Title - Sujet Timber Training Wall Repairs	
Solicitation No. - N° de l'invitation F1700-150464/A	Amendment No. - N° modif. 001
Client Reference No. - N° de référence du client	Date 2015-09-10
GETS Reference No. - N° de référence de SEAG PW-\$PWY-026-7603	
File No. - N° de dossier PWY-5-38145 (026)	CCC No./N° CCC - FMS No./N° VME
Solicitation Closes - L'invitation prend fin at - à 02:00 PM on - le 2015-09-17	Time Zone Fuseau horaire Pacific Daylight Saving Time PDT
F.O.B. - F.A.B. Plant-Usine: <input type="checkbox"/> Destination: <input checked="" type="checkbox"/> Other-Autre: <input type="checkbox"/>	
Address Enquiries to: - Adresser toutes questions à: Liu (PWY), Patty	Buyer Id - Id de l'acheteur pwy026
Telephone No. - N° de téléphone (604) 775-6227 ()	FAX No. - N° de FAX (604) 775-6633
Destination - of Goods, Services, and Construction: Destination - des biens, services et construction: DFO - Steveston Wingdam No. 2 - Richmond, BC

Amendment 001 has been raised to incorporate answers to questions provided by potential bidders and to add Drawing # 37071-007788-00-MA-DRD-1501_RevC.

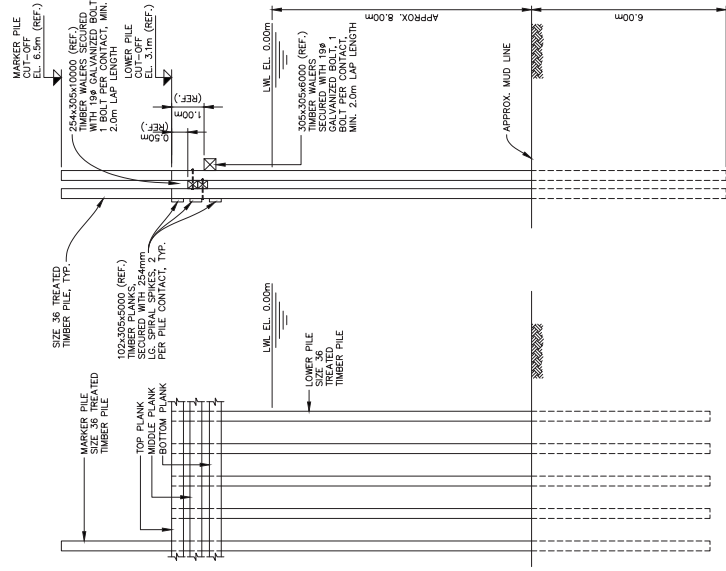
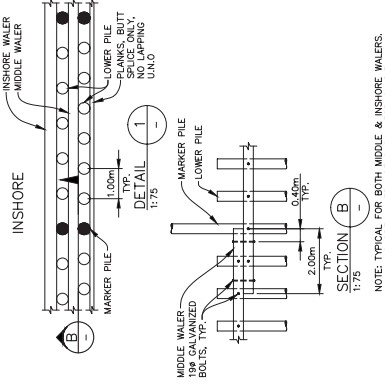
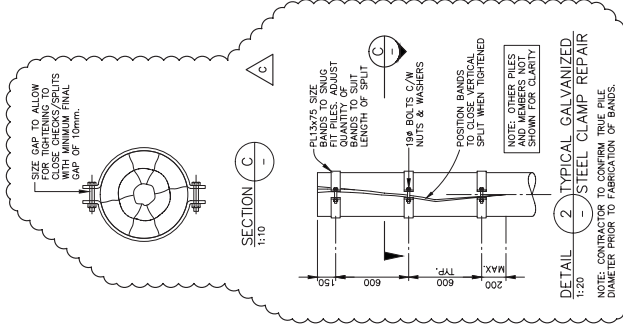
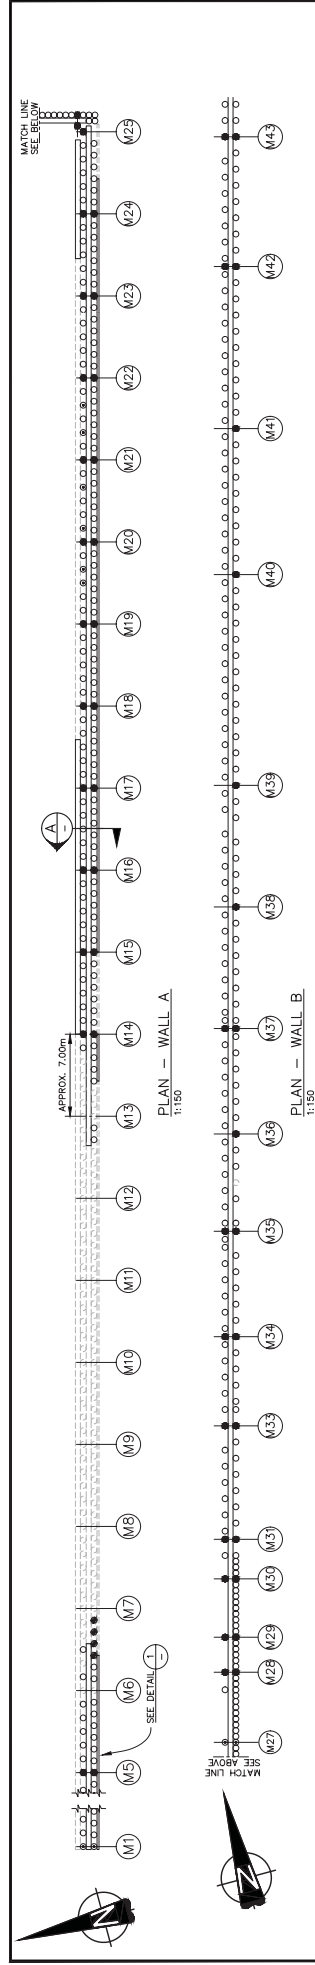
#4 - Regarding Bid Item 9 – please provide a drawing or details of what the galvanized steel pile clamps are supposed to look like. I'm not sure if you are looking for a steel band clamp (width, gauge??) or a more substantial bolted structural clamp (length, steel gauge, # & size of bolts, etc.).?

Steel clamps for split pile repairs shall be galvanized PL 13 mm x 75 mm size band to snug fit piles typically spaced at 600 mm throughout the length of the split. The clamps shall be positioned to close the split pile when tightened and shall use 19 mm diameter galvanized bolts complete with nuts and washers to close the clamps for a snug fit around the pile. Note that clamps shall be sized for a snug fit

and the contractor shall confirm the true clamp size and pile diameter prior to fabrication. Shimming of steel clamps shall not be permitted. View attached drawing.
